Floyd Hill Design - Technical Team

Meeting Summary

August 5, 2022, 9 AM to 12:00 PM

Above: Central Section - West Saddle Area

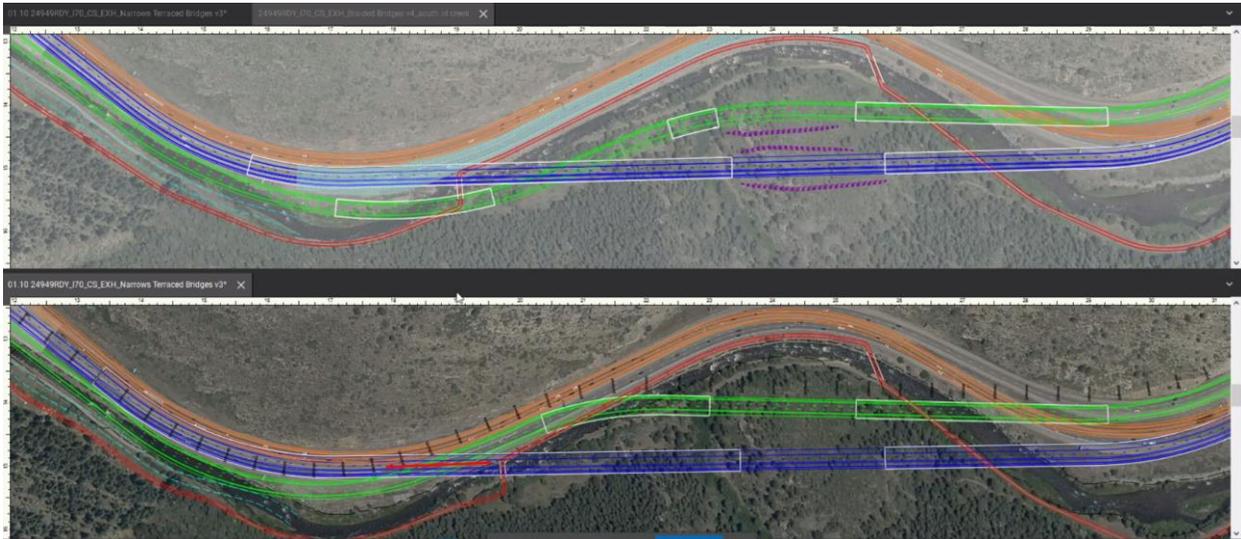
They shared the following image (bottom image is the earlier version; top image is the refined version). The updated version improves constructability by bringing the EB lane to the south side of the creek slightly sooner, creating less conflicts with WB. Additionally, it allows EB to be placed on grade, which then goes up and over Sawmill Gulch. They noted that this is just a concept at this stage and is being brought to the TT for initial feedback to determine if further analysis is warranted.

- **TT Question:** What is the key difference?
 - **Design Team Response:** The span length can be much shorter on the refined version (top image), improving constructability and construction impacts.

A member of the construction team identified that the earlier version would require a complicated construction approach. The refined version makes construction less complicated, but there may be different impacts. Either option will maintain the commitment to continuing the existing trail on the southside of the creek.

Wide view of West Saddle Refinement

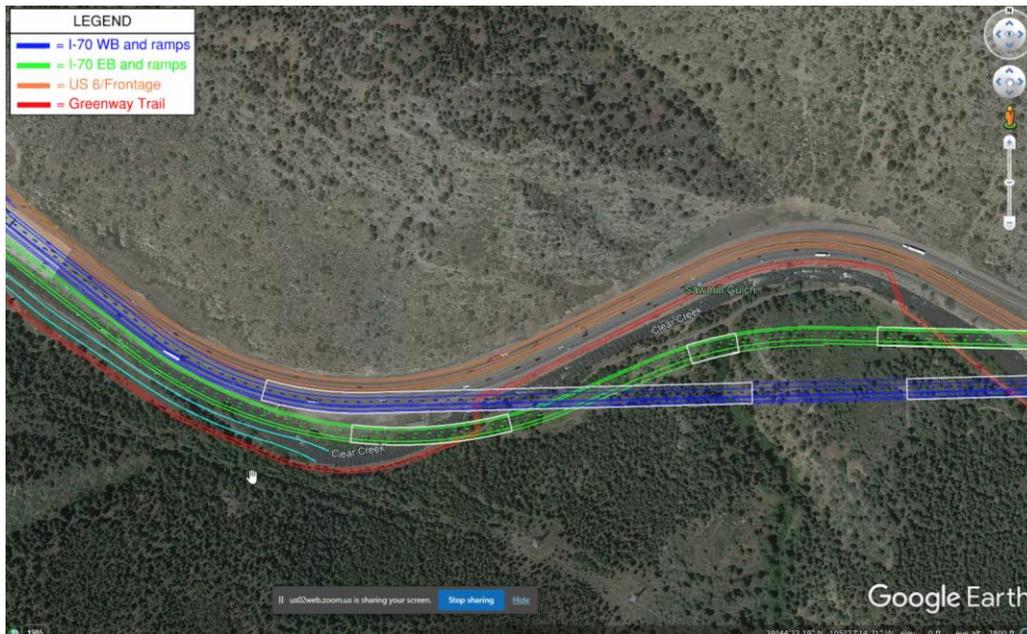
- **TT Question:** Are there significant impacts to the greenway? It seems like putting the highway closer to the greenway would have more impacts.
 - **Response:** The Greenway could be impacted differently. Specific impacts would be discussed and documented in a subsequent ITF.

- **TT Question:** Is there a way to introduce a different curve on WB to meet the necessary site distance requirements on EB?
 - **Design Team Response:** The only way to do this is for WB to move further south, which pushes rock cut further up the mountain. Weighing the impacts, the Project Team saw this as a prohibitive impact.

- **TT Comment:** If the height of the rock cut is flexible, it might be a worthwhile trade off to have additional rock cut if the creek is less heavily impacted.

- **Project Team Comment:** In the refined option there will be a section of the highway adjacent to the trail, and there would likely be a wall. A key issue is determining the extent of additional rock cut and its implications.

- **TT Comment:** Moving the highway closer to an undisturbed forest increases all the risks associated with human activity and roadway impacts.
 - **Response:** The preferred alternative has a similar area of disturbance; the difference here is that EB is now at a different level, coming below WB.

- **TT Question:** Regarding existing impacts vs. new impacts, is there anything that can be done to enhance the creek?
 - **Response:** We have basically optimized where we can move the creek based on where the rock cut is. We essentially ran into a fatal flaw with how far we could move the creek.

- **TT Question:** Are the key impacts for this option related to the future land use plans for the Saddleback area? What about noise impacts?
 - **Response:** What is presented here is likely a reduction in noise, due to the distance of the road from the Saddleback community. We will need to conduct more analysis to understand impacts on future land use.

- **Design Team Comment:** the new option doesn't have WB on a bridge by the rock cut but WB would be on walls. In preparation for ITF, the Design Team will explore ways to modify the alignment to reduce impacts on environmental and cultural resources, and will prepare renderings to depict this option from the greenway perspective.

DECISION: Schedule ITF to evaluate the West Saddle Refinement.

Pictured Above: Preferred Alternative (On Ramp Stays)

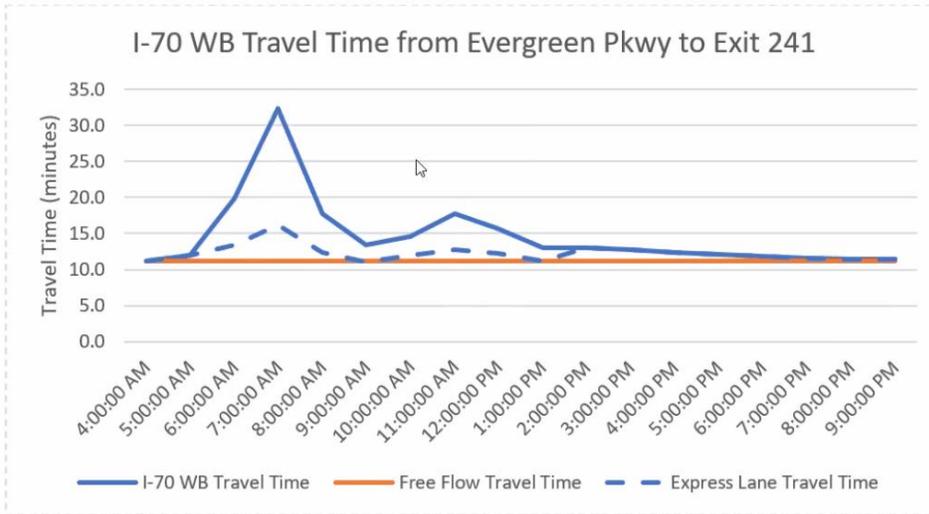
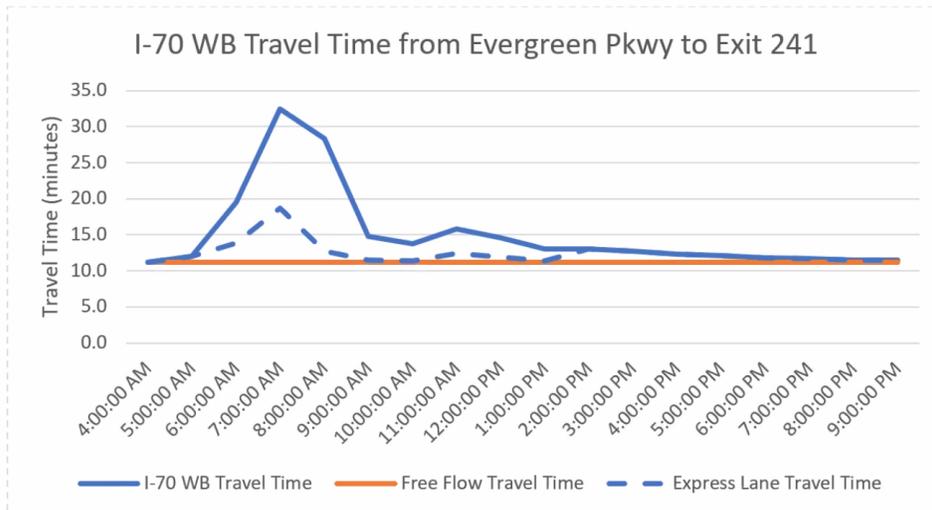
- **TT Question:** What are the assumptions for the model?
 - **Project Team Response:** We assumed a 5% growth rate per year. We adjusted the toll rate to reach free flow; this is what would likely happen based on traffic numbers.

The design team said that on the model of the Preferred Alternative, traffic split between the frontage road and I-70. A key question to predict what traffic would look like without the US 6 On Ramp is “what would happen if all the traffic that was coming from US 6 was moved to I-70? Could I-70 handle it?” The outcome of that model (the Updated Preferred Alternative) looks similar to the Preferred Alternative. In short, the model doesn’t predict significant traffic implications for I-70 if the on ramp is removed. It was noted the model did not factor in additional travelers who believe traffic will be better

- **TT Question:** The model doesn't factor in additional transit vehicles that might be added in coming years?
 - **Project Team Response:** Correct.
- **TT Question:** What does "ban cars on 40" mean on the graph?
 - **Project Team Response:** This was just instructions for the model to prevent it from rerouting cars to 40. Cars will not be banned from 40.

- **Comment:** I am still concerned that removal of the ramp would increase traffic at exit 243. With the removal of the ramp people will get off and not be able to get back on until 243, which just moves the congestion down the road.
- **Comment:** There should be some form of additional education and signage to help encourage people to stay on 70 and not move to the frontage road when there is more capacity on 70.
- **Question:** Can a ramp be added 20 years down the road if it turns out to be needed?
 - **Response:** Yes, we want to have a design that would be open to this addition. The new ramp would likely be slightly further west.

The key takeaway was that adding a lane will increase capacity and the removal of the WB US 6 On Ramp would not dramatically increase traffic. It was also noted that FHWA will still need to approve the change.

DECISION: Pursue the additional work with CDOT and FHWA to move forward with the removal of US 6 On Ramp. This decision doesn't preclude the ramp.
